**Re; Precinct B - Sites 2A & 3A,
Walker Street, Rhodes
Environmental Wind Assessment**

This report presents the results of a review of the Architectural Documentation as it has progressed towards a DA submission.

Drawing Name: LANDSCAPE PLAN

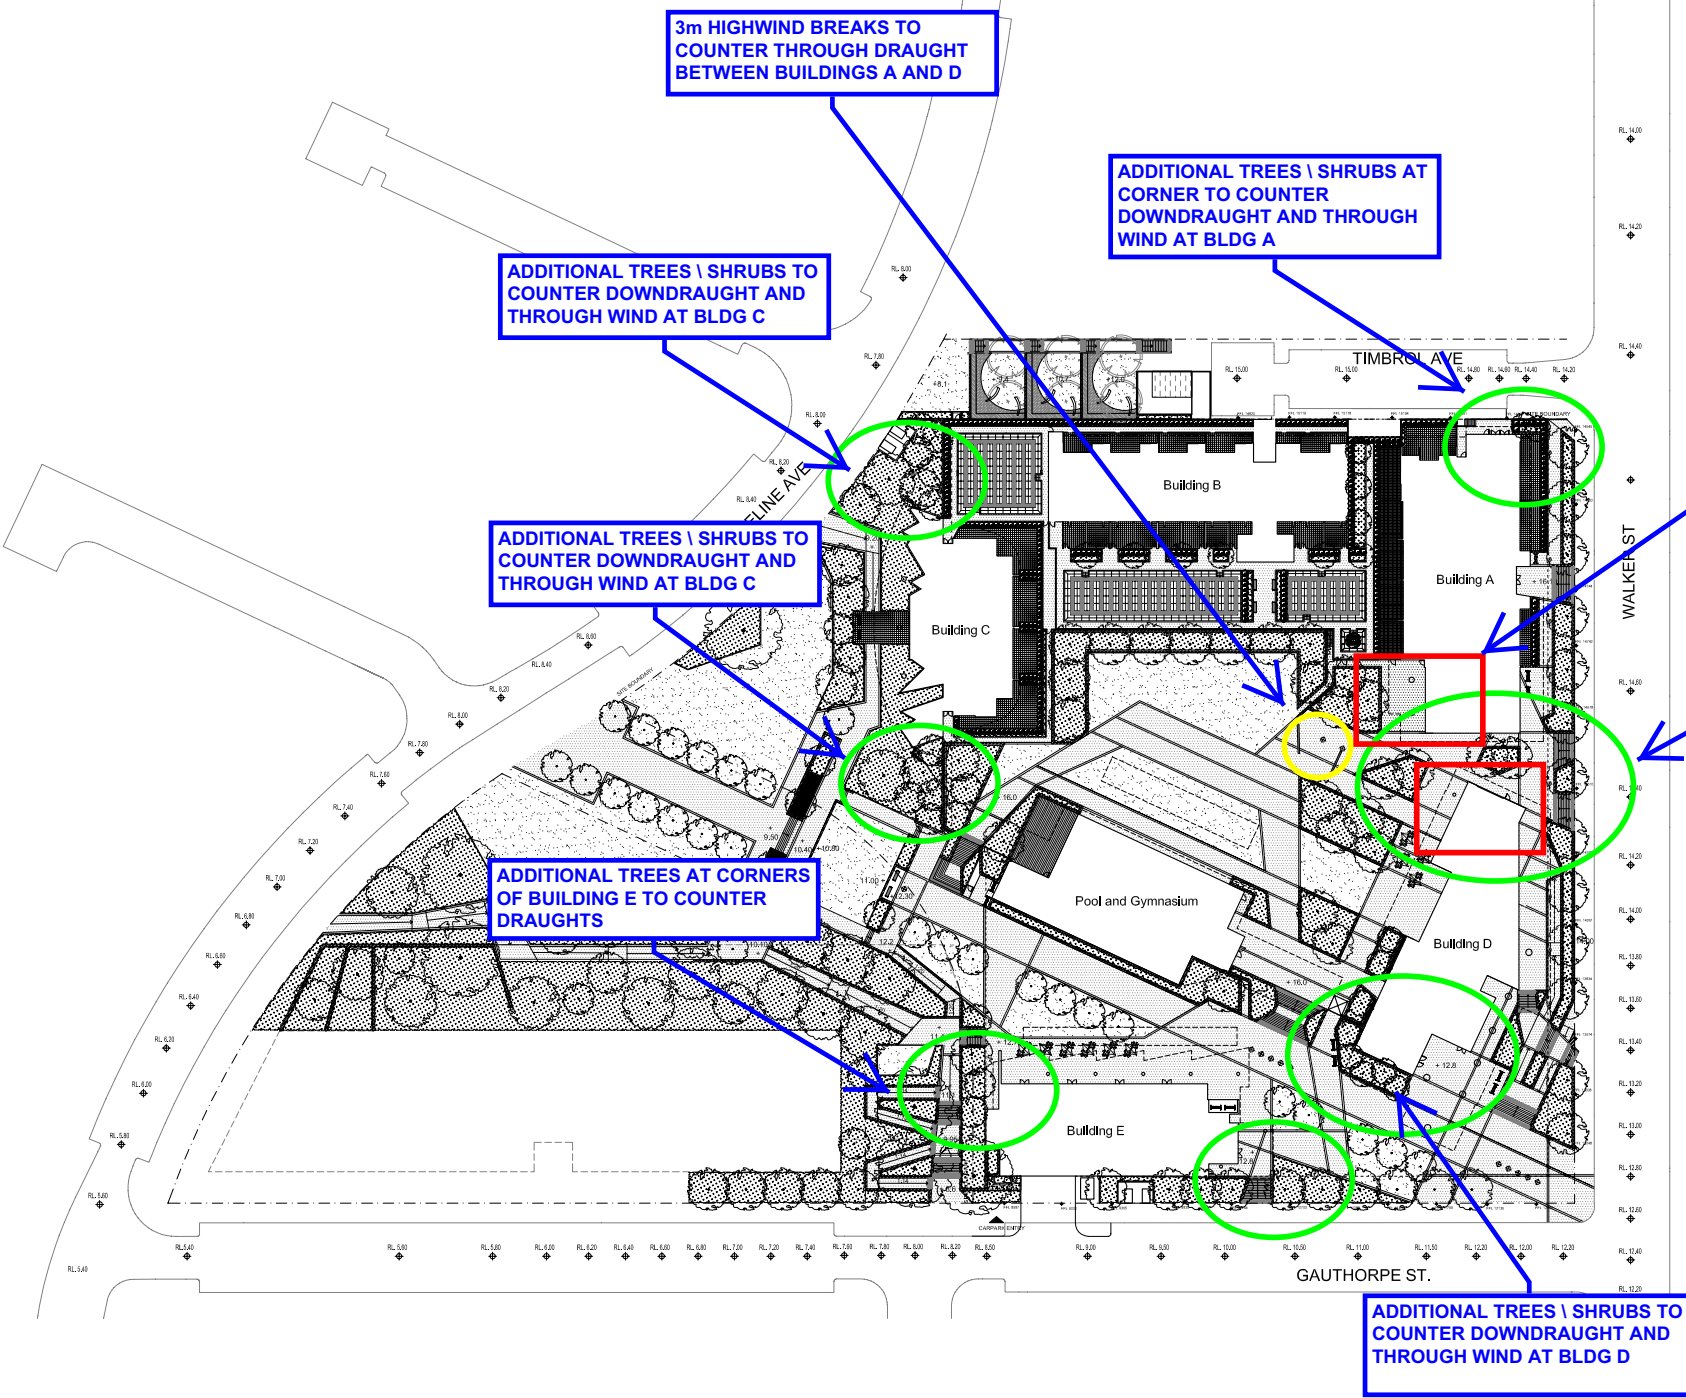
On the south side a wind-break feature has been incorporated between buildings A and D along with substantial landscaping so as to prevent wind conditions at this level exceeding the criterion for walking comfort for both westerly and easterly winds. Extension of the podium level canopies will also assist in controlling downdraft wind conditions at this point. The attached drawing indicates this.

To ensure that wind conditions meet the criterion for comfort for walking around this building we have introduced landscaping and screen wind-break features at the corners to keep pedestrian walkways away from the corners and to lift these corner flows so that they do not impact on the pedestrian entry points.

The step up in level from Shoreline Avenue creates the ability to make provision for wind-break screening or landscaping at the north-west and south-west corners which also creates a no-go zone for pedestrian traffic. The attached drawing indicates this.

To ensure that wind conditions meet the criterion for comfort for walking around these buildings we have introduced significant landscaping at the corners to keep pedestrian walkways away from the corners and to lift these corner flows so that they do not impact on the building entry points.

3m HIGHWIND BREAKS TO COUNTER THROUGH DRAUGHT BETWEEN BUILDINGS A AND D

ADDITIONAL TREES \ SHRUBS AT CORNER TO COUNTER DOWNDRAUGHT AND THROUGH WIND AT BLDG A

ADDITIONAL TREES \ SHRUBS TO COUNTER DOWNDRAUGHT AND THROUGH WIND AT BLDG C

ADDITIONAL TREES \ SHRUBS TO COUNTER DOWNDRAUGHT AND THROUGH WIND AT BLDG C

ADDITIONAL TREES AT CORNERS OF BUILDING E TO COUNTER DRAUGHTS

ADDITIONAL TREES \ SHRUBS TO COUNTER DOWNDRAUGHT AND THROUGH WIND AT BLDG D
